September 2, 2026

John Wiesemann, Code Enforcement Officer
Town of Casco
635 Meadow Road
Casco, Maine 04015

**Re: Response to Review Comments
 Country Village Assisted Living Expansion
 960 Meadow Road
 960 Meadow Road Holdings, LLC - Applicant**

TURNING MOVEMENT EXHIBITS

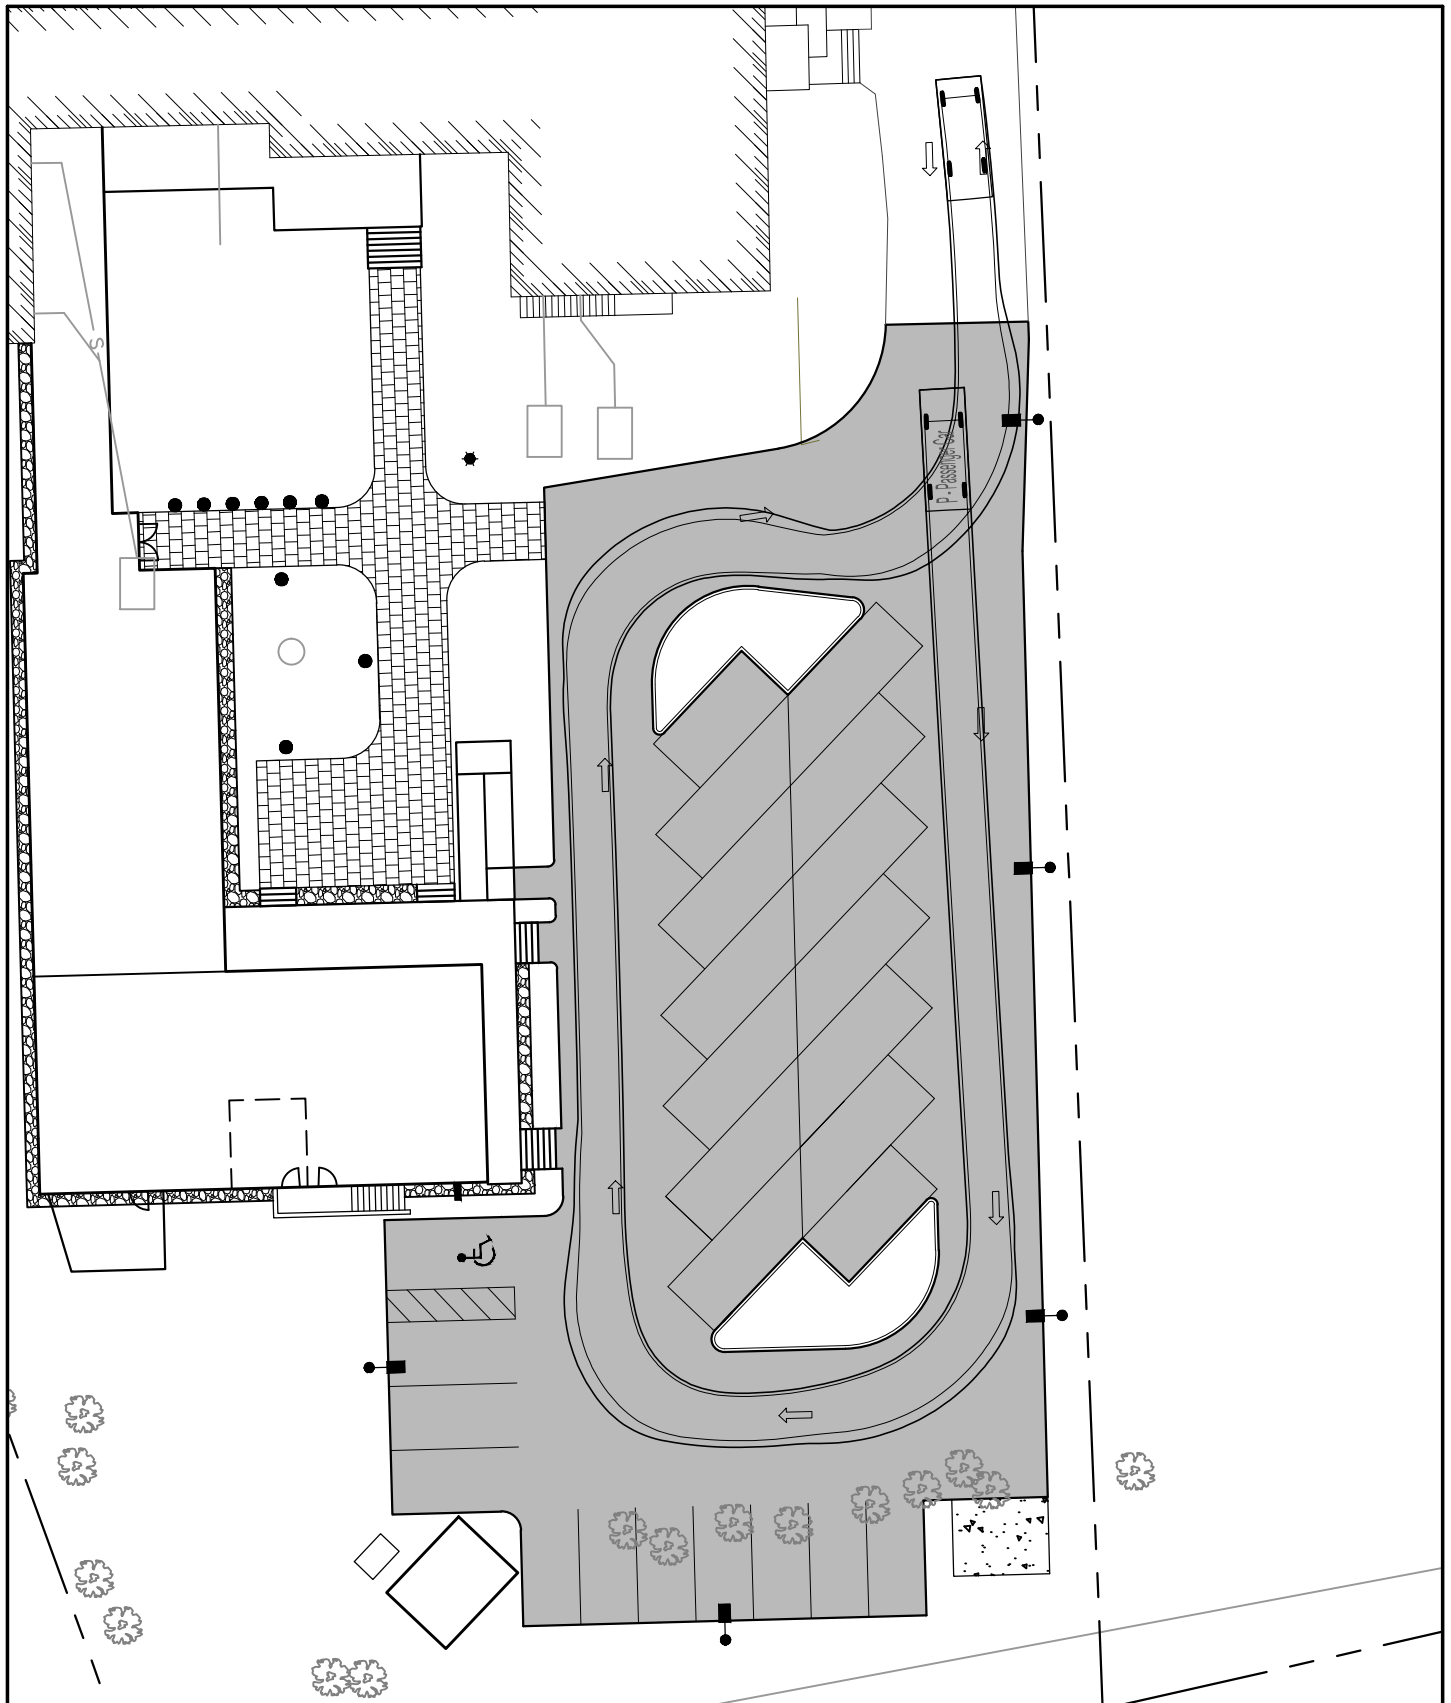
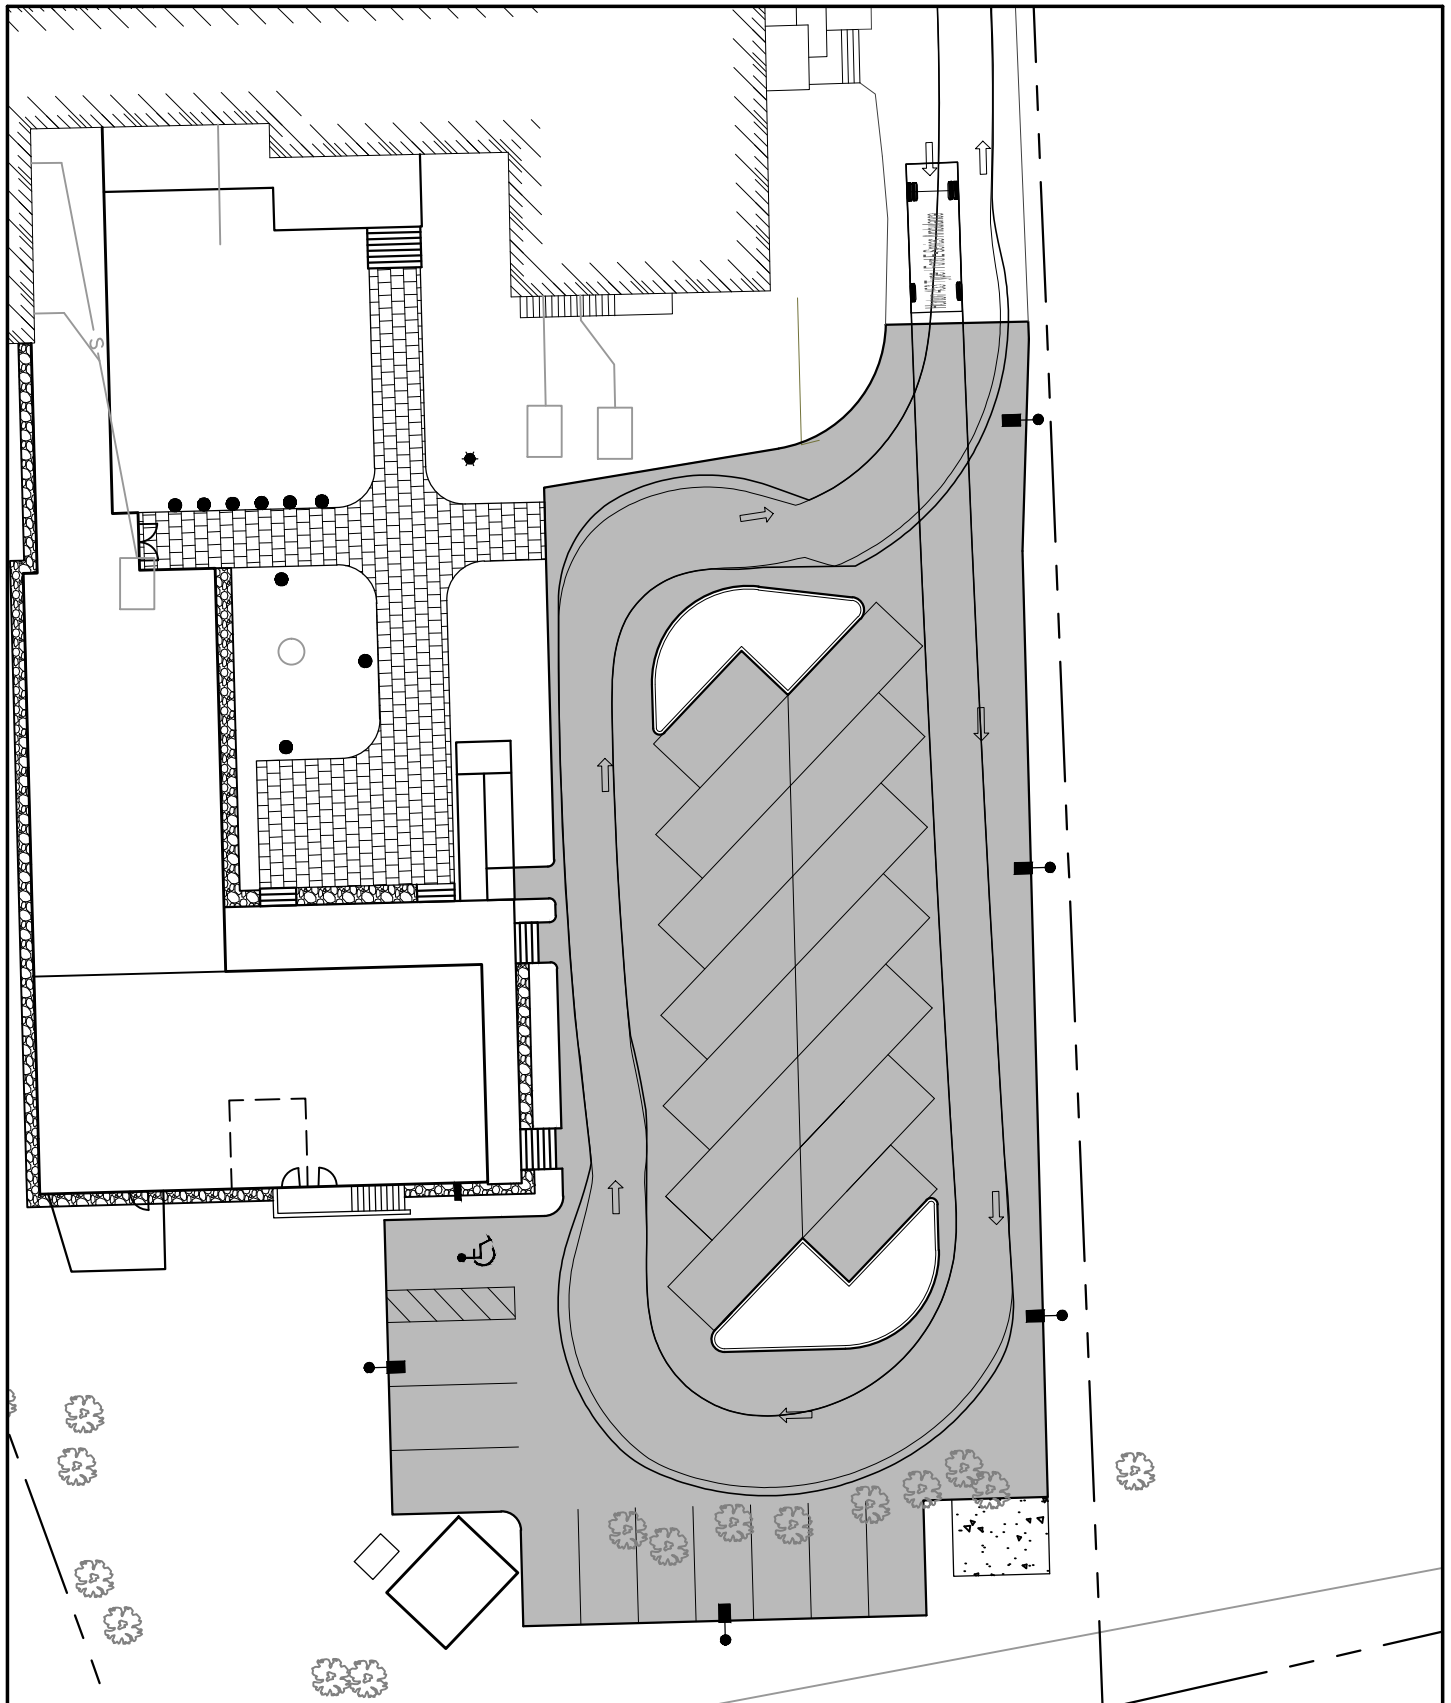
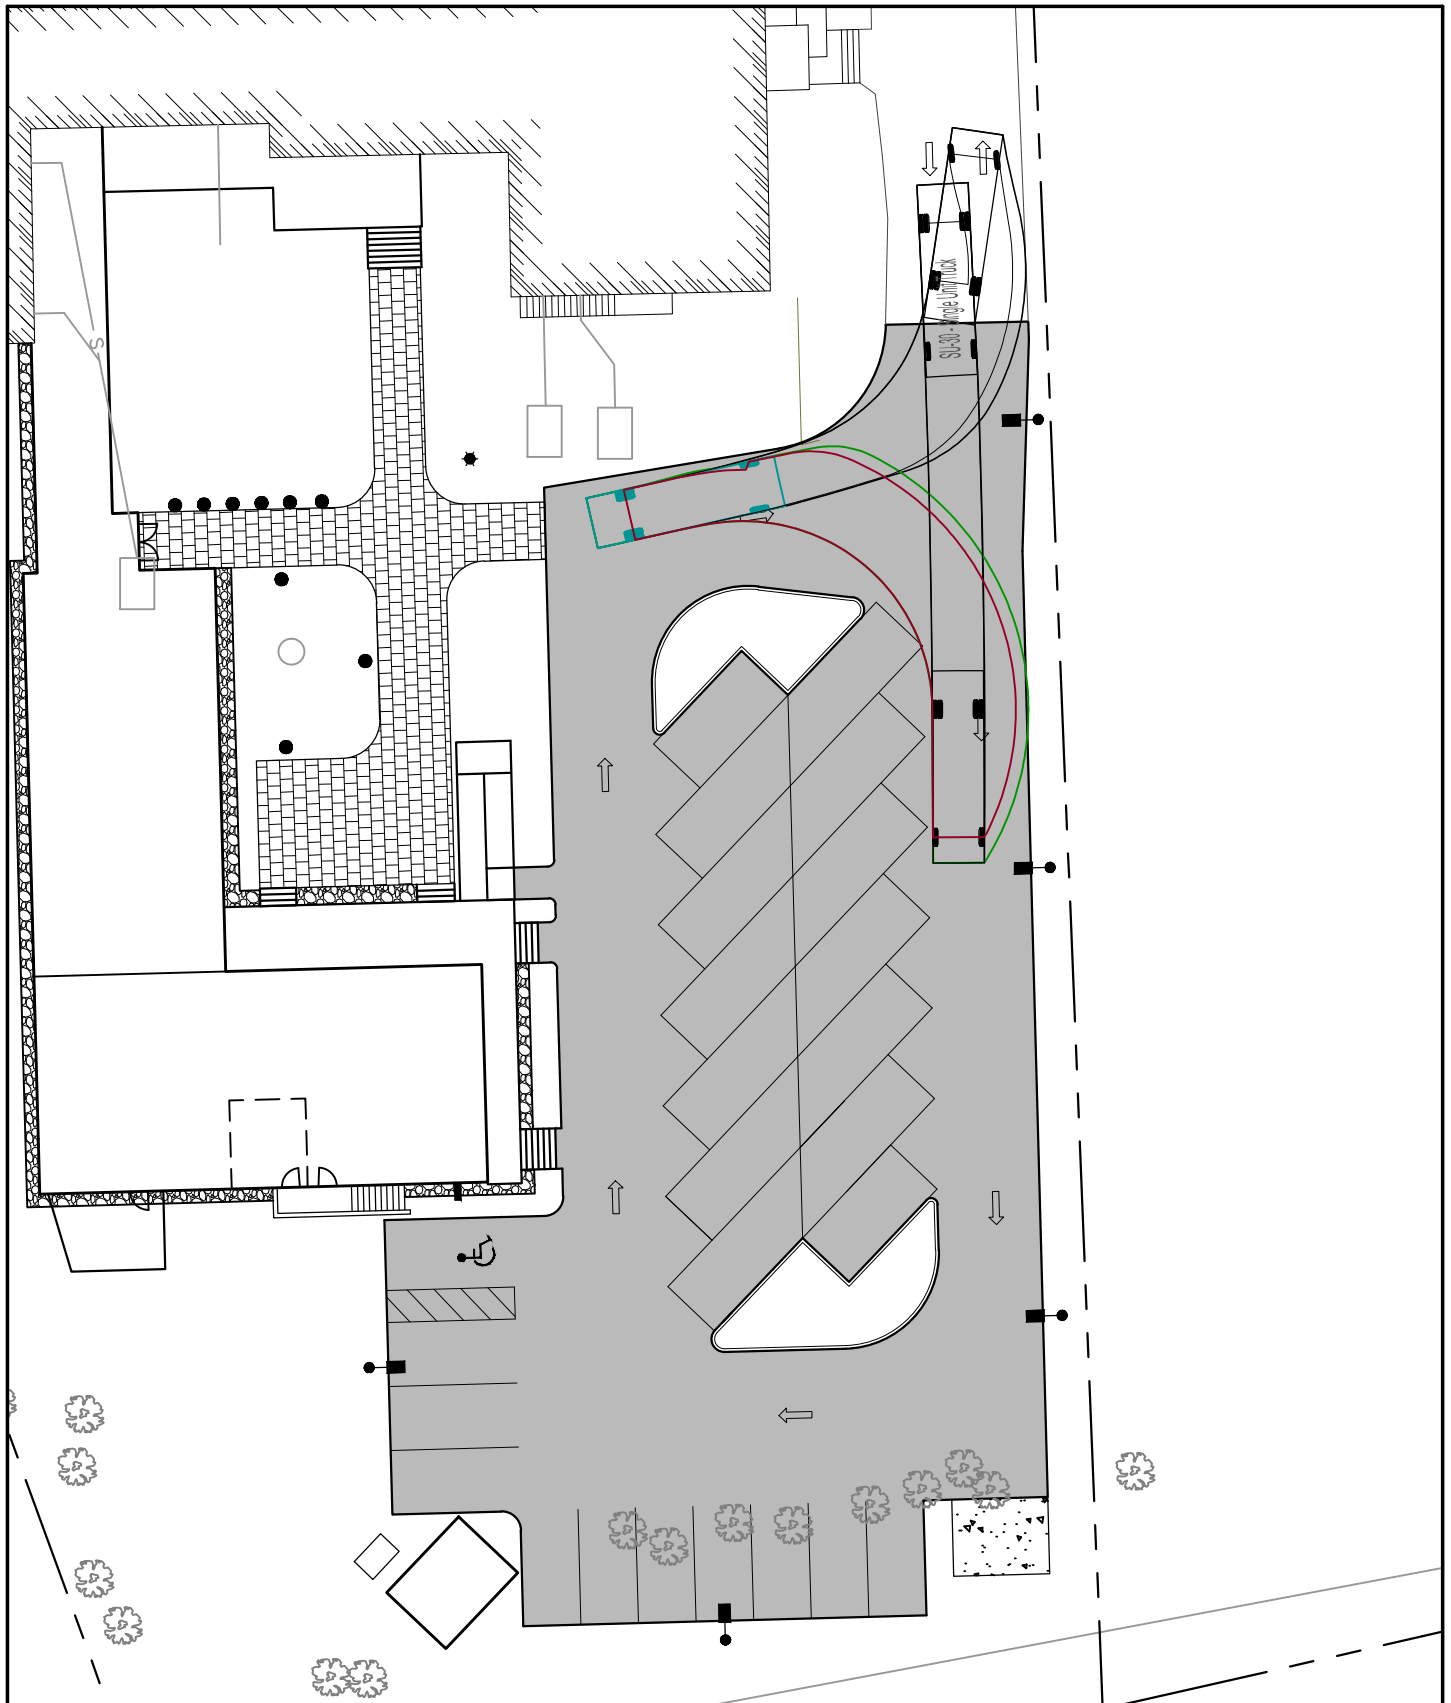
Comment 7 - *The turning radius for vehicles around the rear island is tight and the lane narrows to 16 feet due to the angular parking. A turning template should be shown to see what the largest vehicle is that can manipulate the turn. Teh concern is larger trucks might not be able to maneuver if cars are parked there.*

Response 7 – Included in this submission are turning movement exhibits for the different vehicles that would typically be onsite.
